ADDENDUM NO. 2

Bid No.: 2526-05

Project: Roofing at Various Sites

Owner: Los Alamitos Unified School District

OAK MS - SCOPE
CLARIFICATIONS

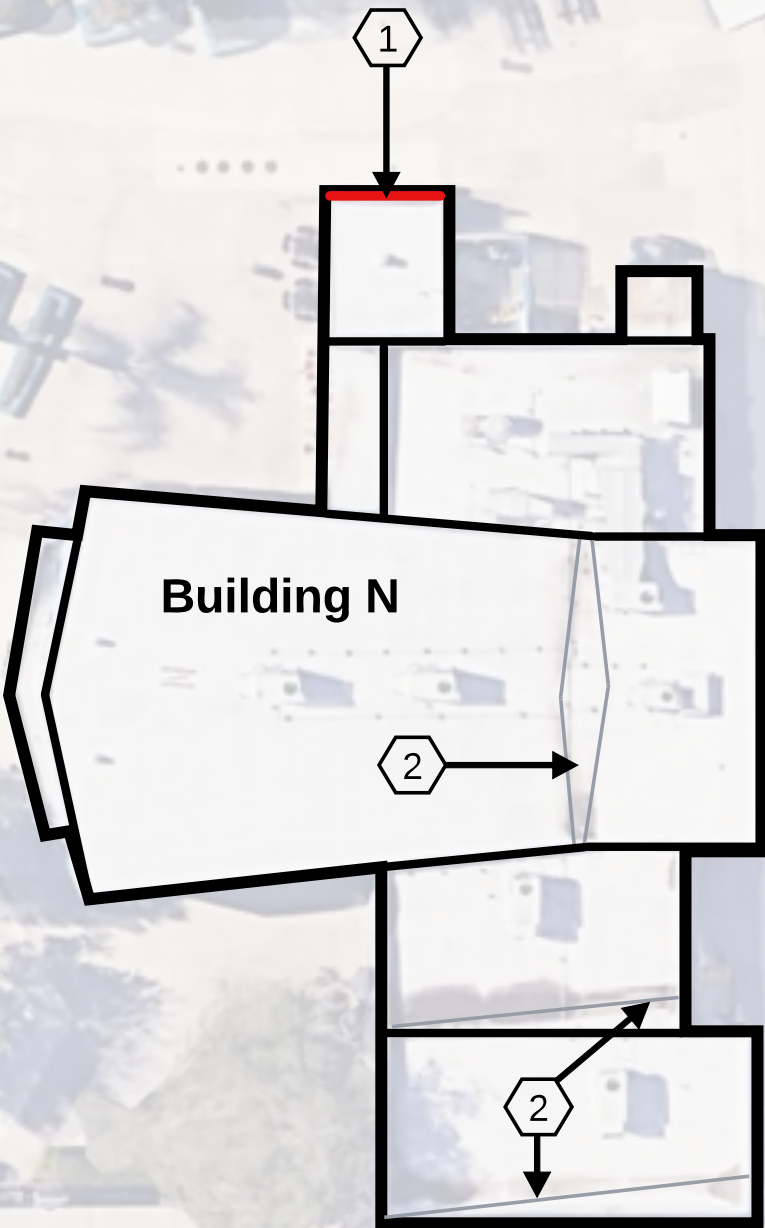
a. Parapet Wall Flashing and Coping

At parapet walls indicated on the drawing set where the roof membrane currently terminates beneath existing counterflashings, the parapet walls shall be fully encapsulated with KEE flashing membrane. New coping caps shall be installed per manufacturer-supplied details.

b. Waterways and Drainage Improvements

At indicated waterways where ponding water is prevalent, contractor shall expand and enhance existing crickets using tapered polyisocyanurate insulation to ensure positive drainage and prevent ponding water.

1. INDICATED PARAPET WALLS WHERE THE ROOF MEMBRANE CURRENTLY TERMINATES BENEATH EXISTING COUNTERFLASHINGS SHALL BE FULLY ENCAPSULATED WITH KEE FLASHING MEMBRANE, AND NEW COPING CAP SHALL BE INSTALLED PER MANUFACTURER-SUPPLIED DETAILS.
2. EXISTING CRICKETS SHALL BE EXPANDED AND ENHANCED USING TAPERED POLYISO INSULATION TO ENSURE POSITIVE DRAINAGE AND PREVENT PONDING WATER.
